**FRANKSTON PLANNING SCHEME  
AMENDMENT C46  
OLIVERS HILL AND SWEETWATER  
CREEK EROSION MANAGEMENT  
OVERLAY AND LOT  
RESTRUCTURE PLAN**

**PANEL REPORT**

**APRIL 2010**

Figure 2 Olivers Hill Lot Restructuring Plan Sheet 1

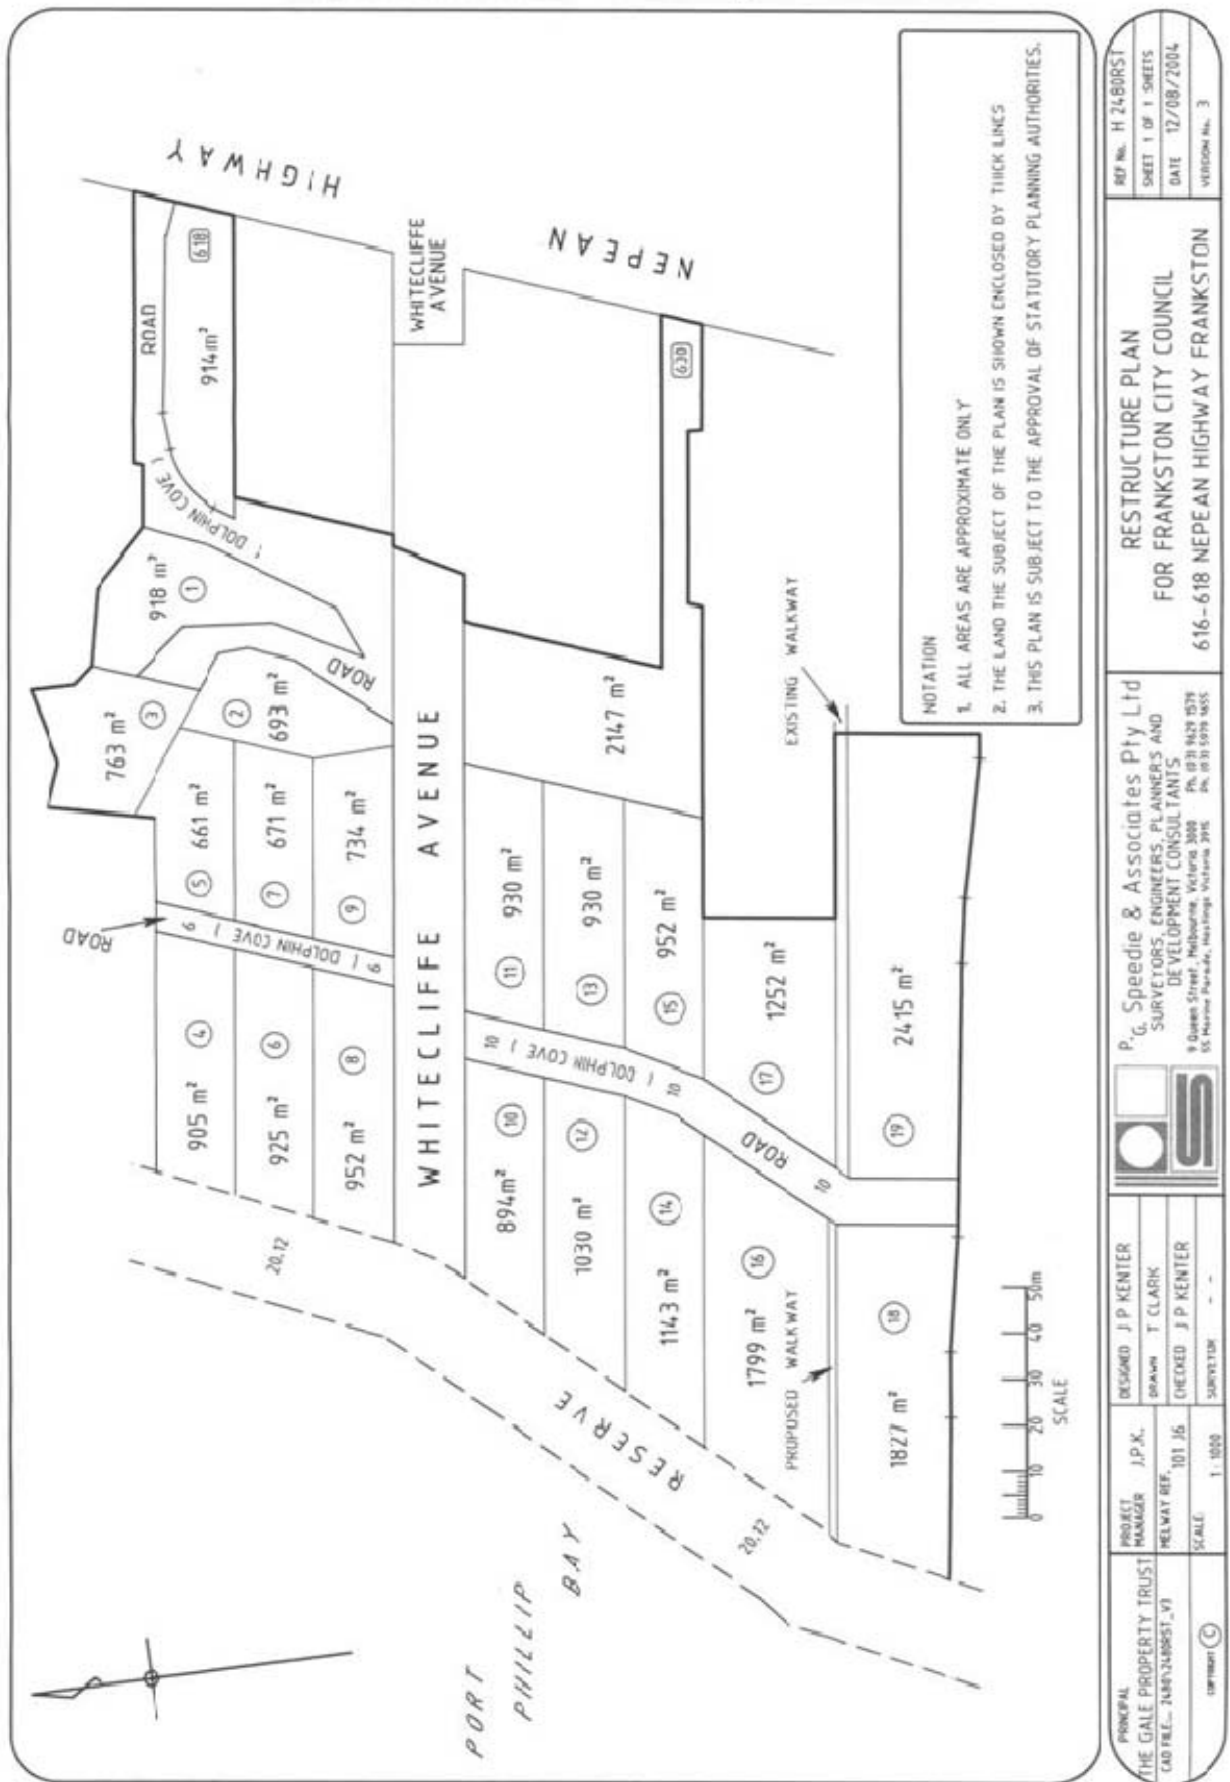
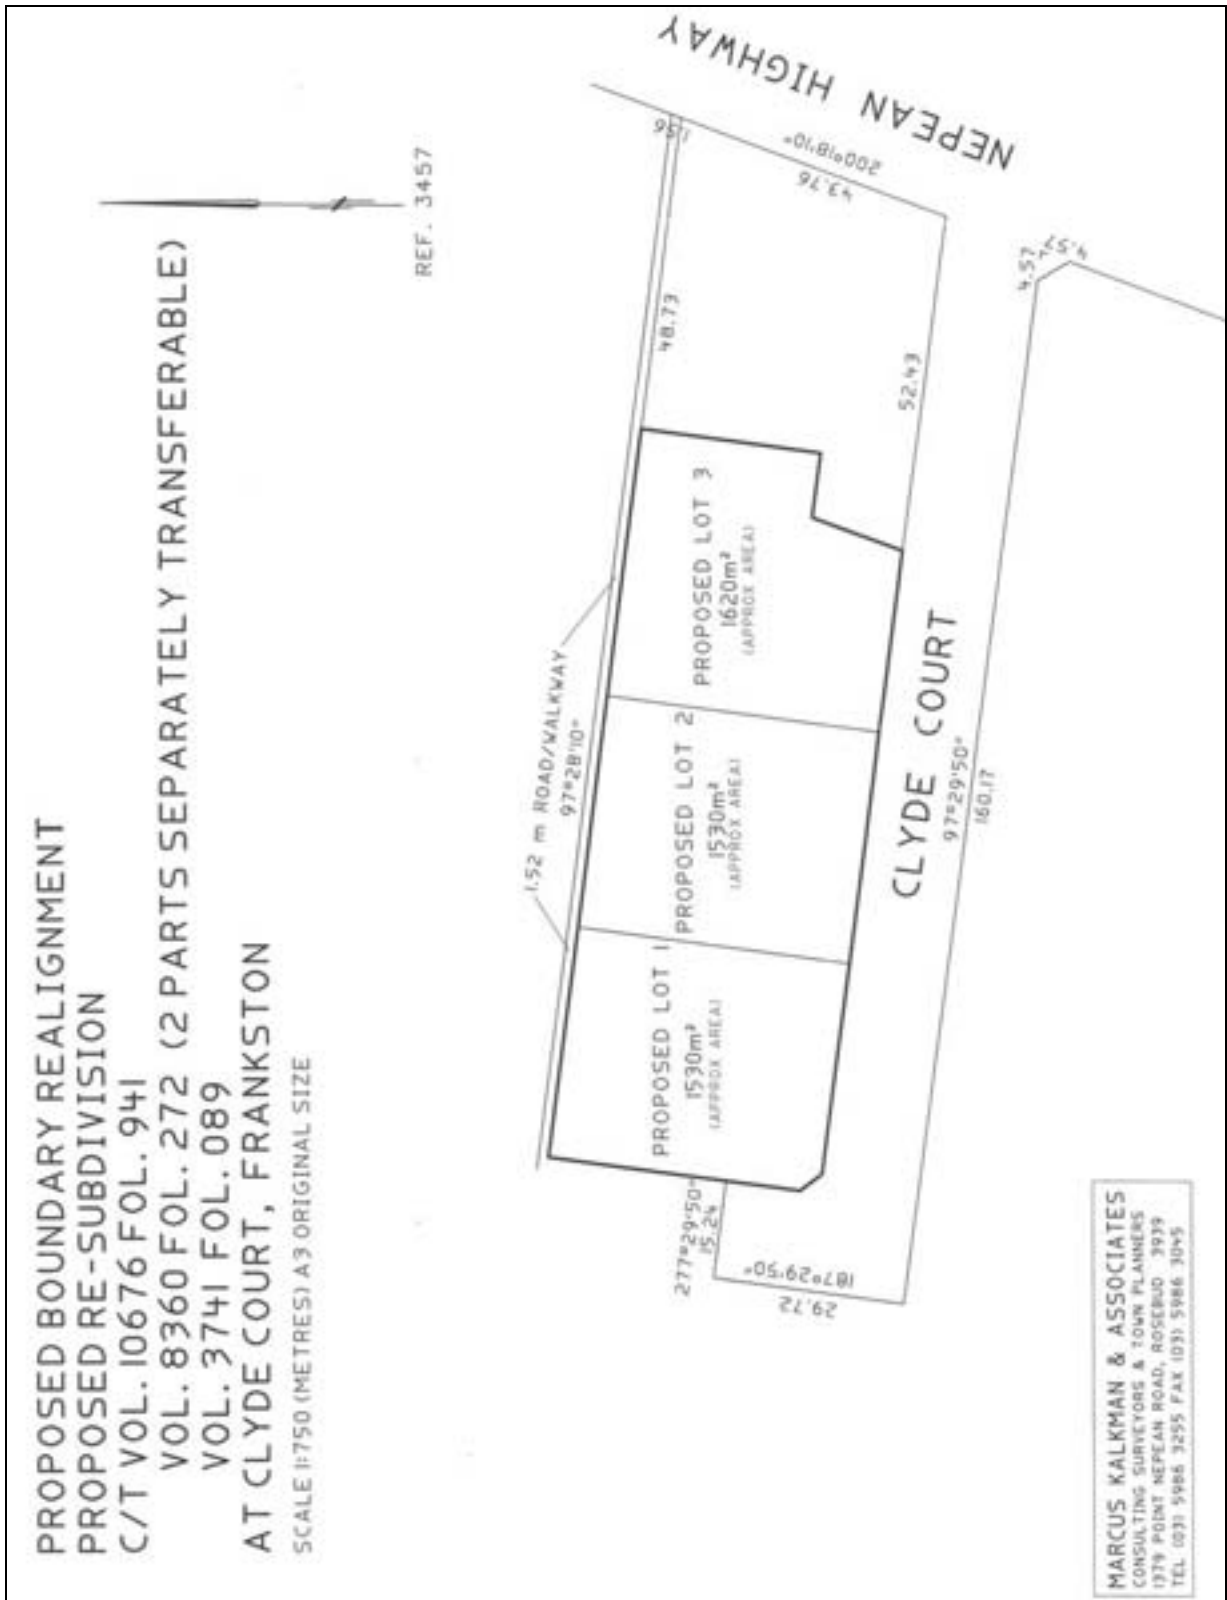
Ms Hosking and Ms Lardner were both critical of the time limits imposed by the Restructure Plan for the commencement and completion of development. Ms Lardner's submission was that these times should be extended to 2 years to commence (for Whitecliffe Avenue) and 4 years for Clyde Court. Both areas should then have 10 years to complete the development (15). For its part Council agreed to support a 4 year limit (7).

In the Panel's view, the scheme need not necessarily concern itself with resolving the second question (i.e. the length of the permit) but that it is sensible to address the length of the control itself. It should do so for reasons of orderly and proper planning. This would give the Council some flexibility in extending planning permits issued under the provision and not necessarily be bound by a restrictive provision (such as say, 2 years) which might require a planning scheme amendment to correct.

**The Panel recommends that the timing of the restructure plan be amended.**

Delete the following words:

*The exemptions provided for in this document expire after a limited period of time. The circumstances and times are set out at Clause 52.03 of the Frankston Planning Scheme.*

and replace with:
